**PUR-1378**  
**ADDENDUM NO. 3**  
**INVITATION TO BID**

**THE MARYLAND THEATRE EXPANSION  
IN HAGERSTOWN, MARYLAND**

**DATE: Thursday, March 29, 2018**

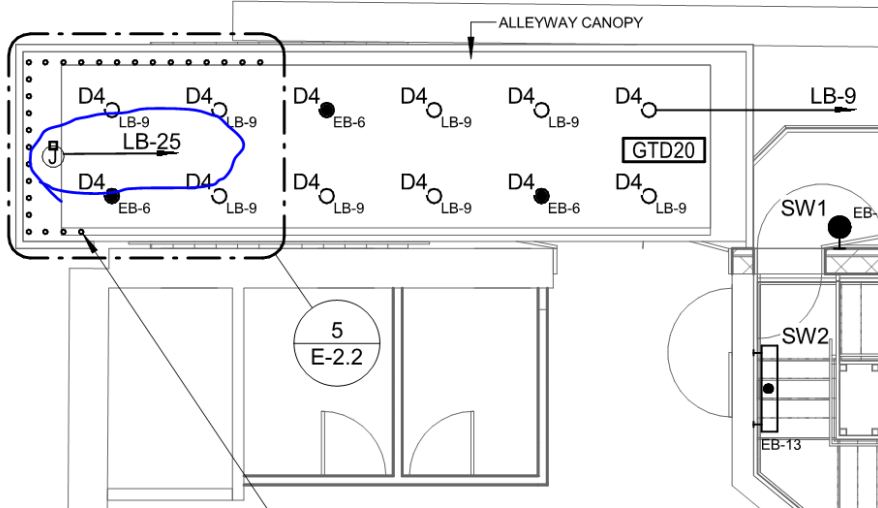
**ITEM NO. 18:** *Inquiry:* A2.2 calls for shelf lighting at back bar millwork. This lighting is not shown on the electrical lighting plan for this area E-2.2 so we don't know the fixture manufacturer/model numbers, the panel the fixtures are wired to or how they are switched.

*Response:* Remove note. There is no light shelf behind bar.

**Branch Panel: LB**

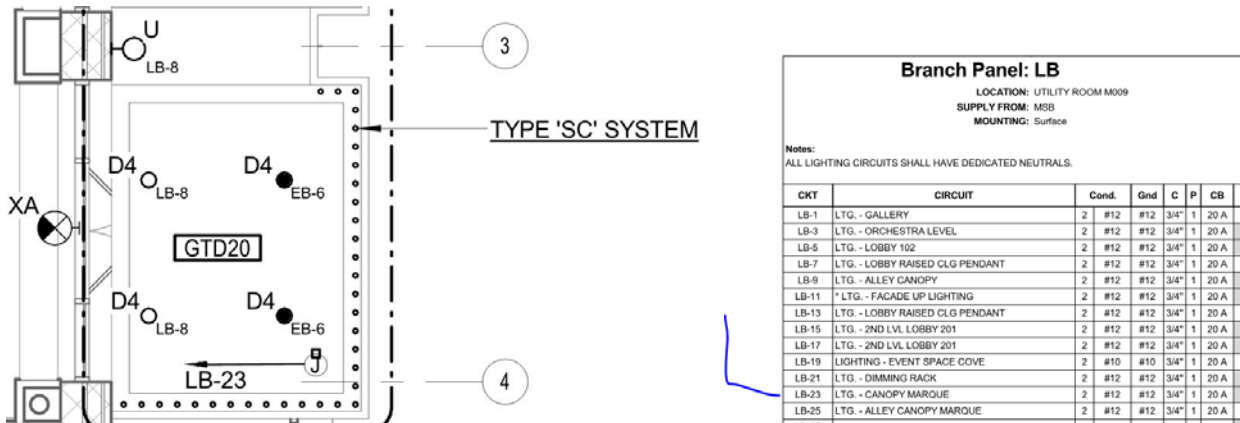
**ITEM NO. 20:** *Inquiry:* To what panel are the orchestra level alleyway canopy Type SC lighting run?

*Response:* LB-25

**PLAN - STAIR 6 FRAMING**  
 1/4"=1'-0"

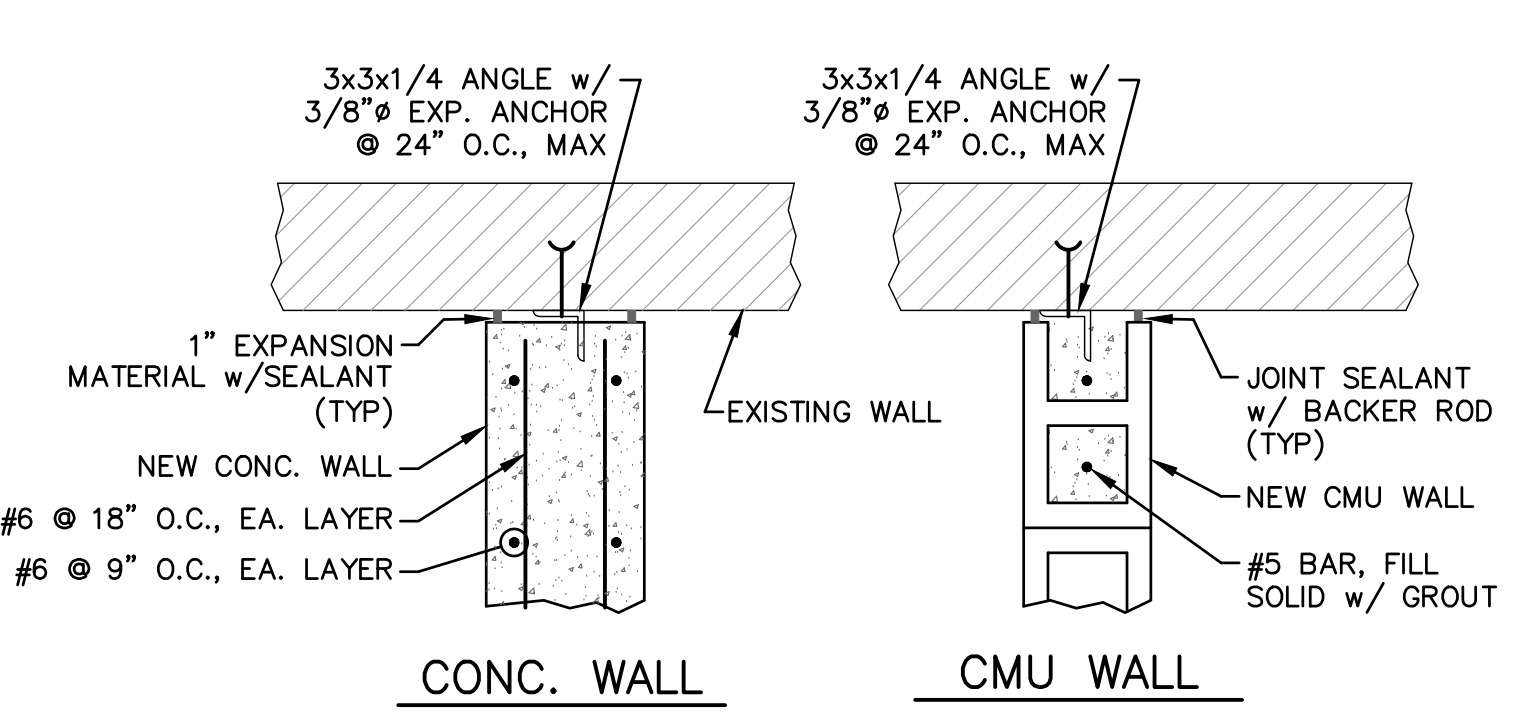
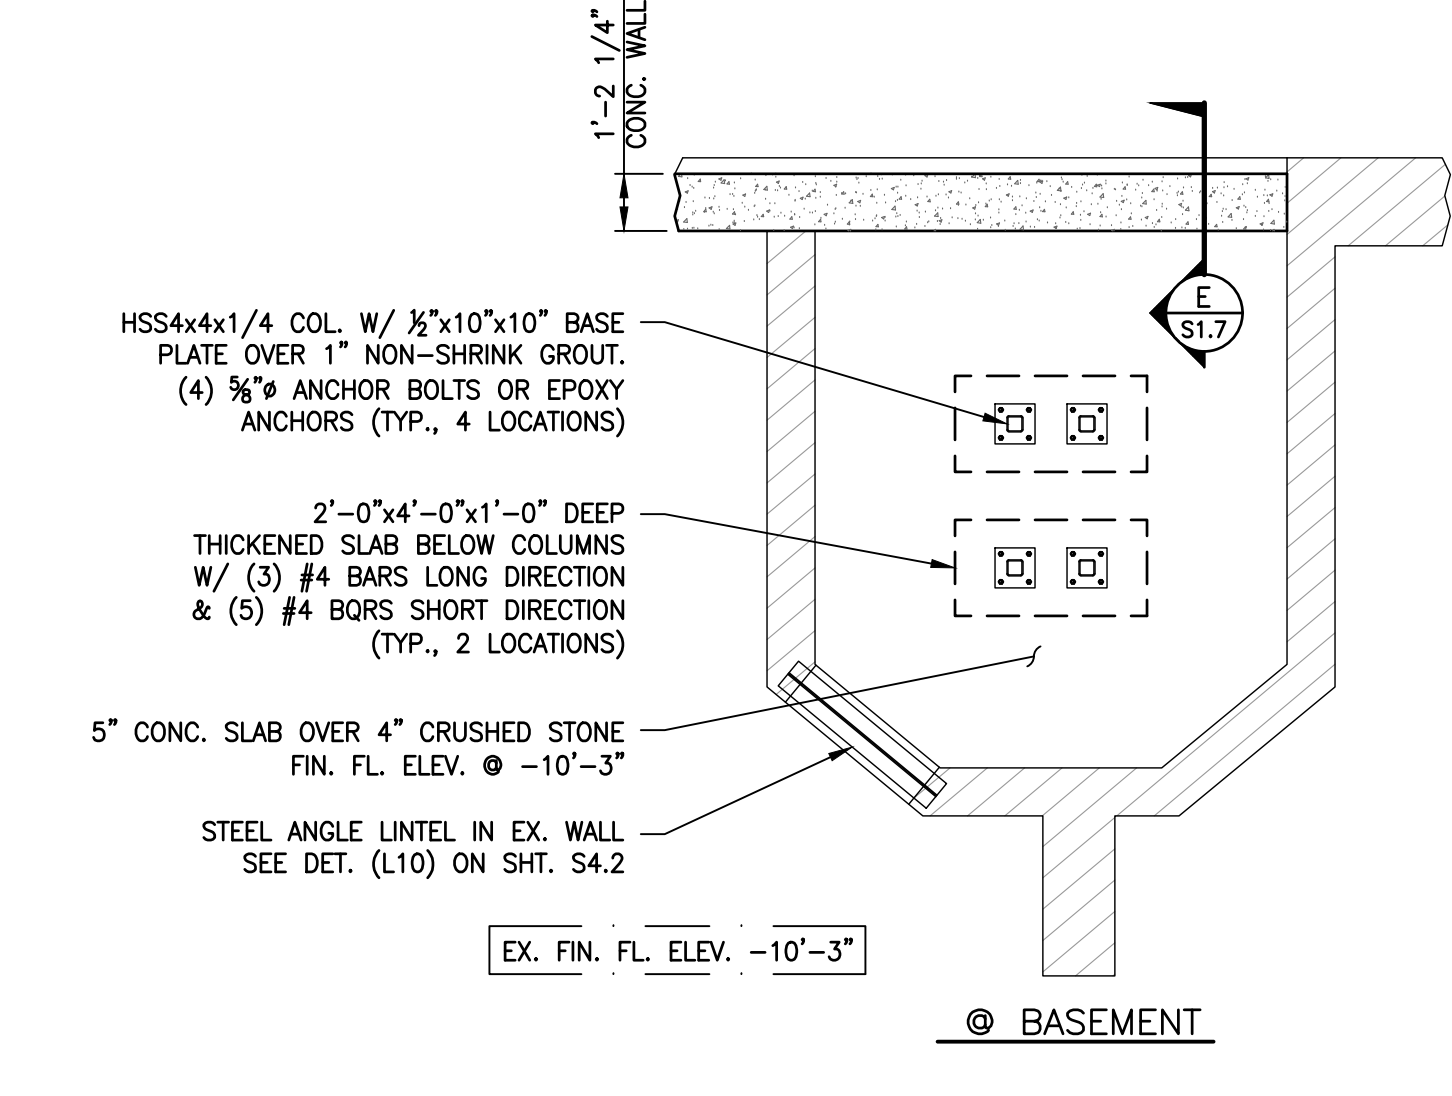
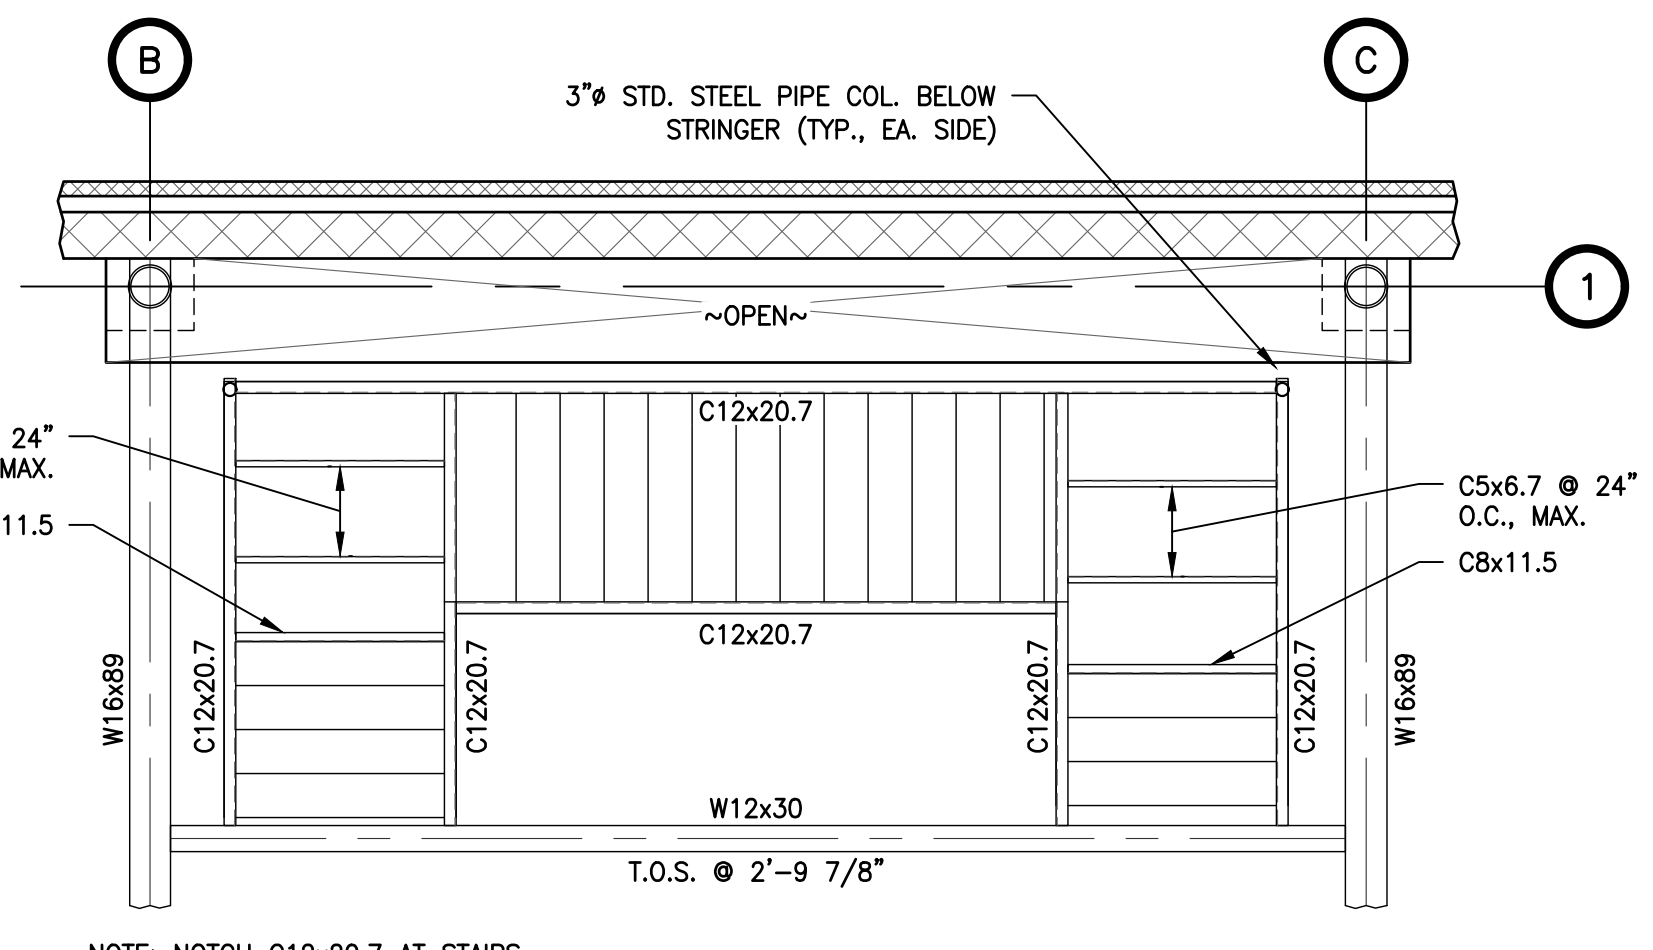
- ITEM NO. 51:** SHEET S-1.7 – STAIR FRAMING PLANS (SHEET ATTACHED)
- REVISE** Detail G/S-1.7 for Stair 6 Framing Support
- ITEM NO. 52:** SHEET S-3.0 – STRUCTURAL SECTIONS (SHEET ATTACHED)

**4**  
 S3.2  
**SECTION - FOOTING/WALL @ EX. THEATER WALL**  
 3/4"=1'-0"

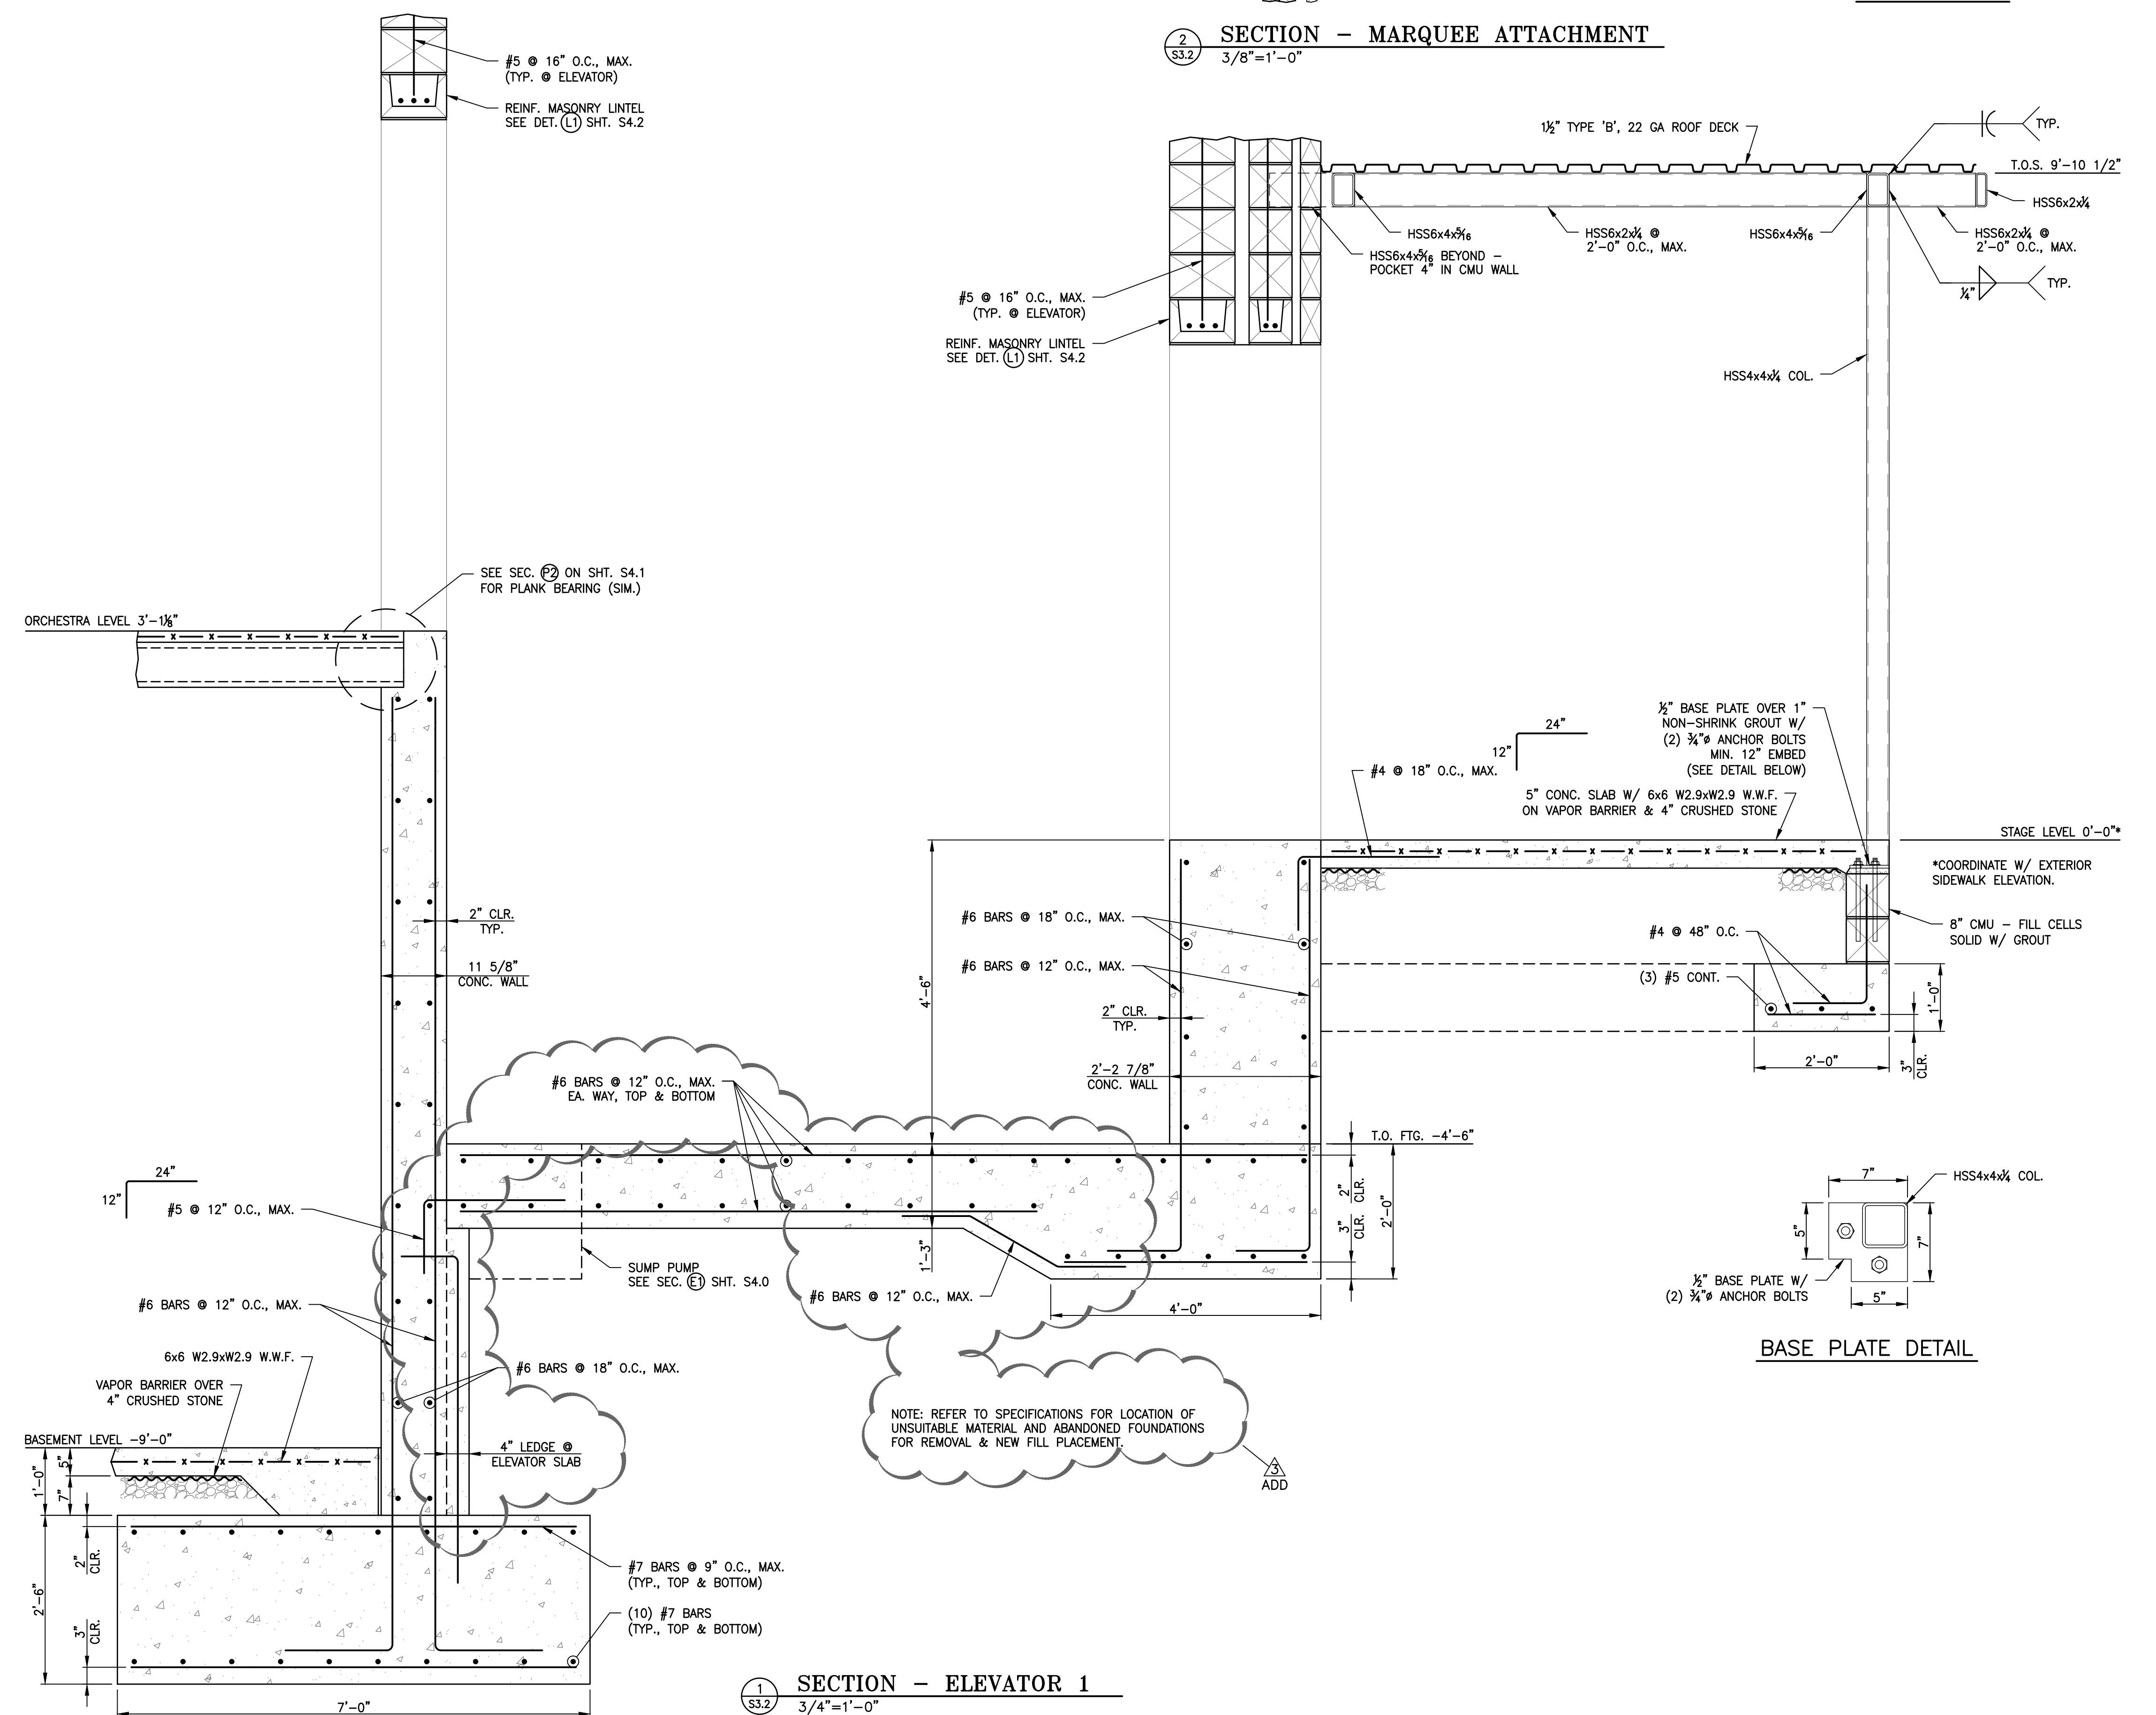
- REVISE** Revised Detail 4 – to show underpinning concrete requirement
- ITEM NO. 54:** SHEET S-4.0 – TYPICAL STRUCTURAL DETAILS (1) (SHEET ATTACHED)
- ADD** Note for base bid underpinning
